**Re: Adequacy Response #2, Technical Revision No.  
TR2 Tellier Gravel Pit, Permit No. M-1998- 058**

Map 2 - Reclamation Plan

Tellier Pit

## Tellier TR Response #2

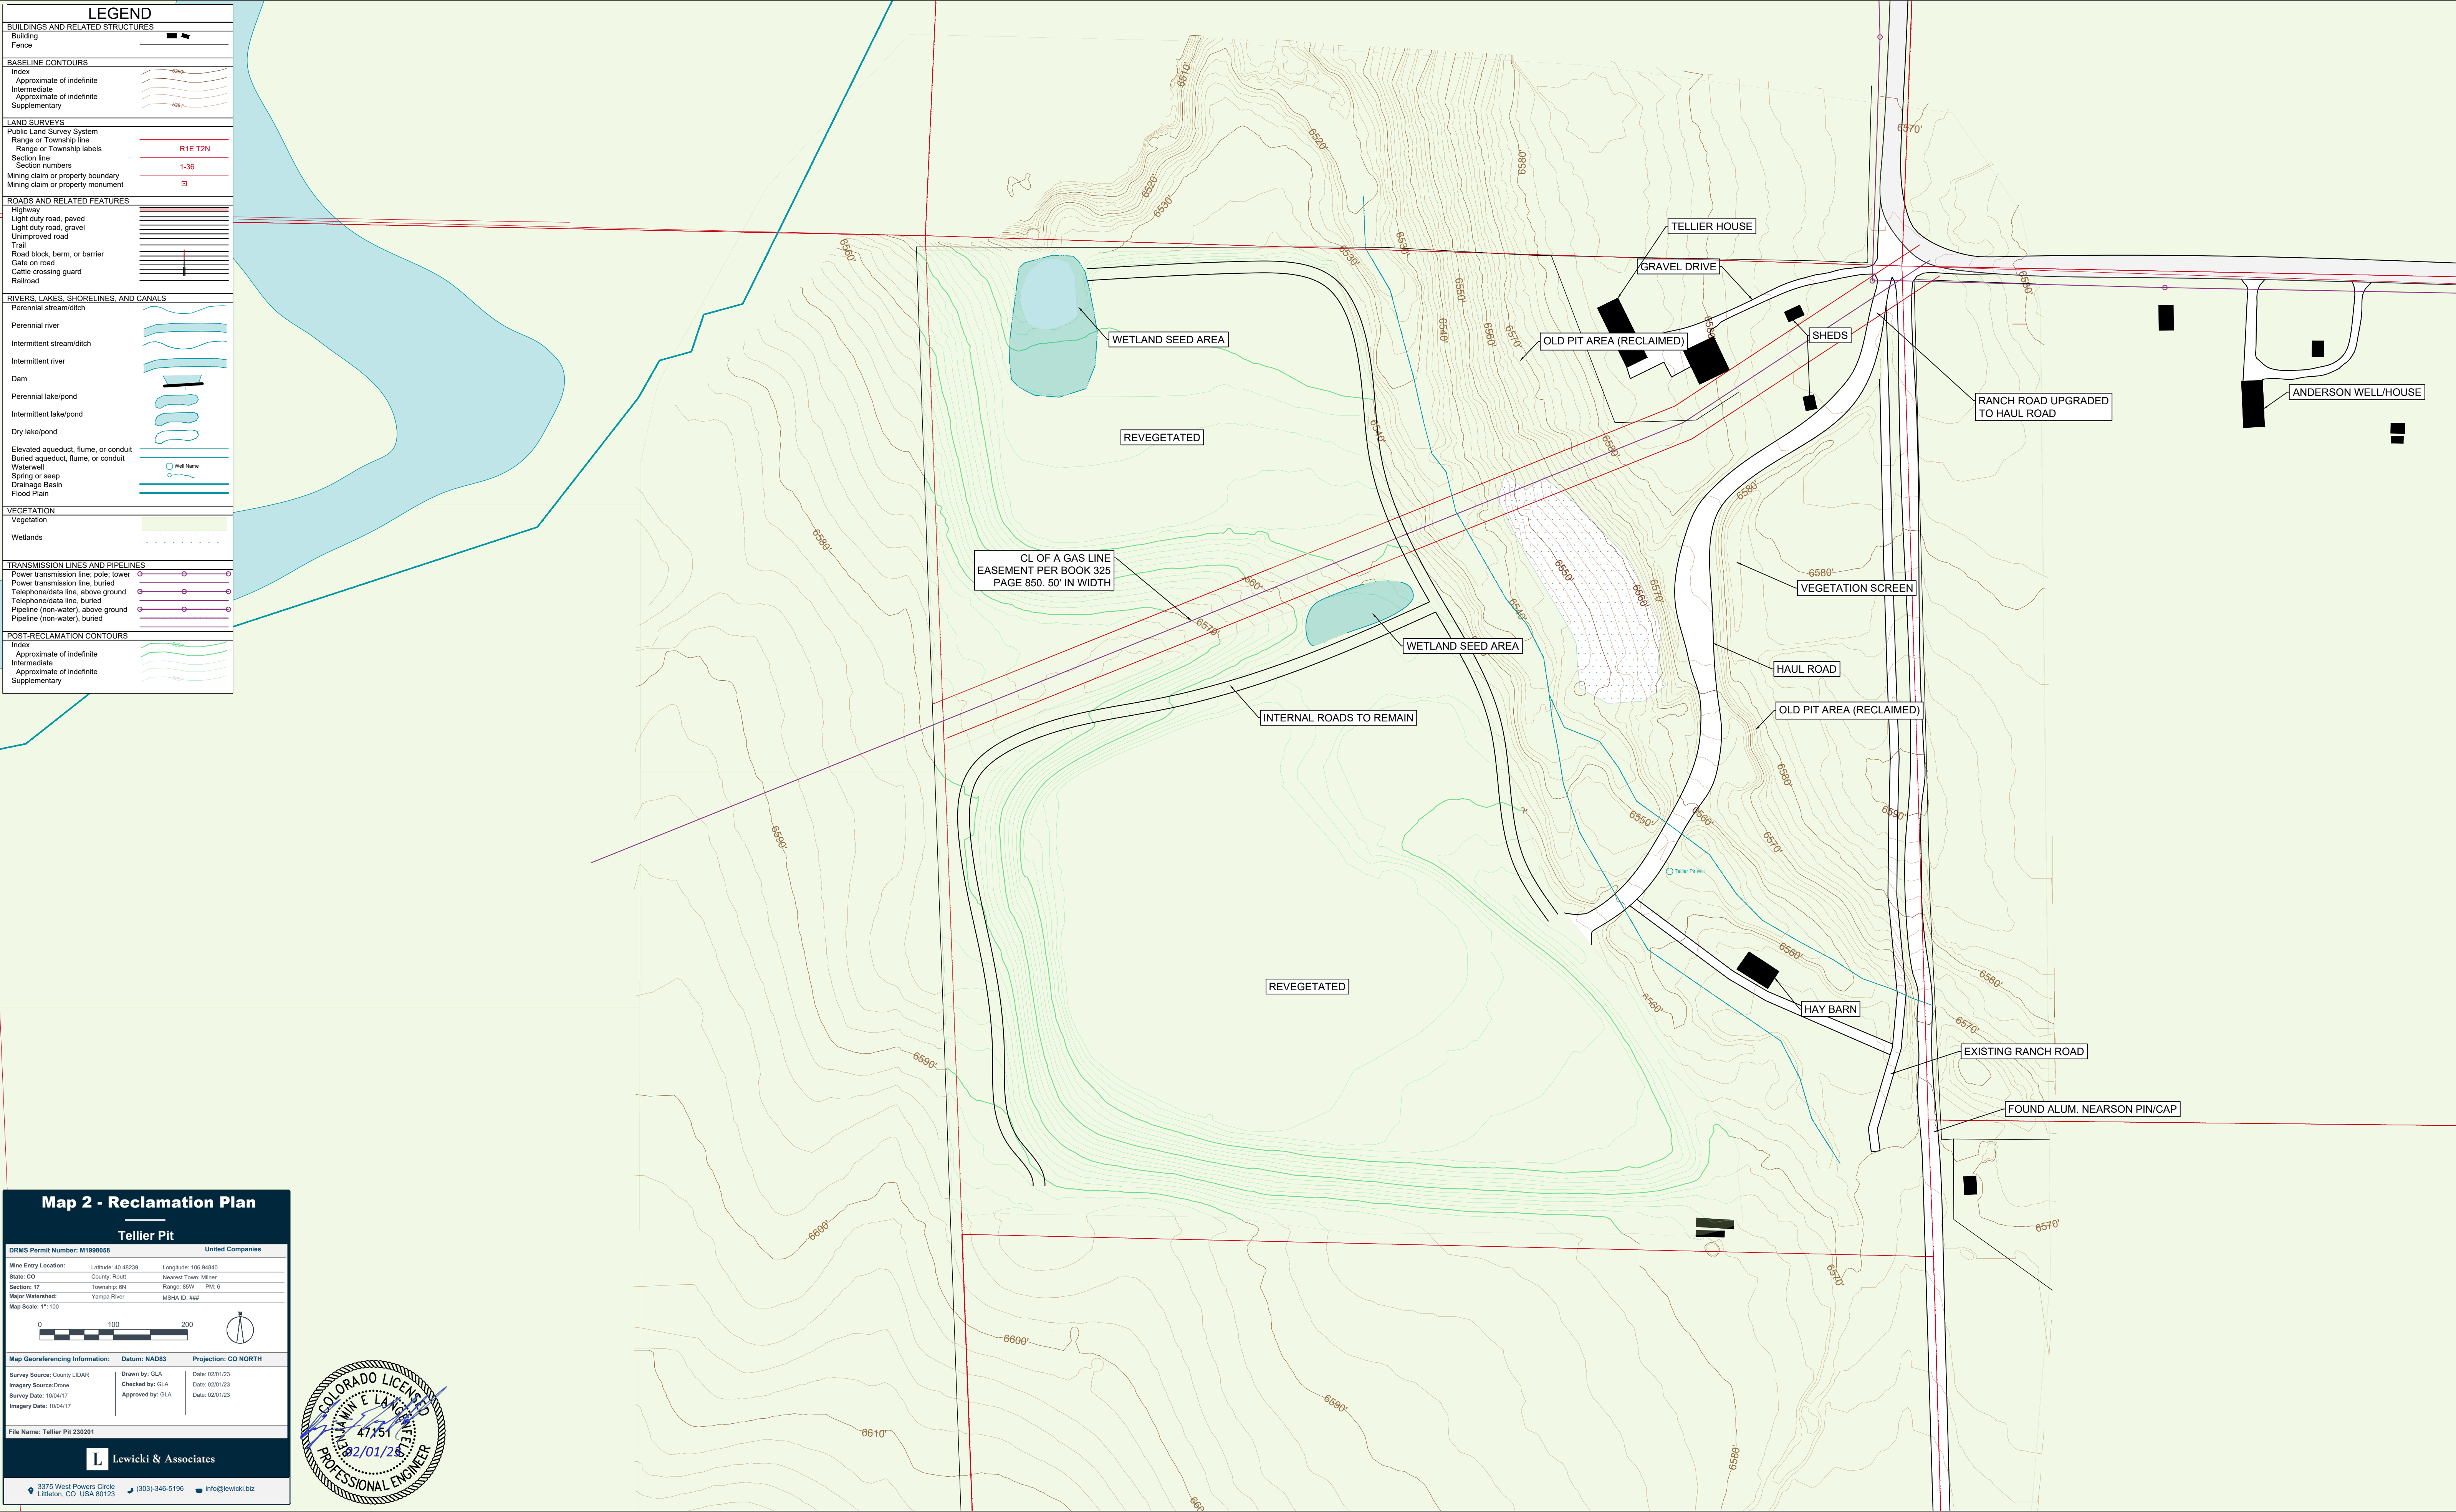
- The wetland-appropriate seed mix provided above will be used during reclamation in the two wetland areas.
9. In response to Item 7, you provided an updated reclamation plan map. This updated map does not contain the depiction of the two approved wetland areas. Please revise the submitted map to show the wetland areas as referenced on currently approved reclamation plan map, received October 26, 1998 (enclosed).

- a. Please see the reclamation attached which shows the wetland areas.
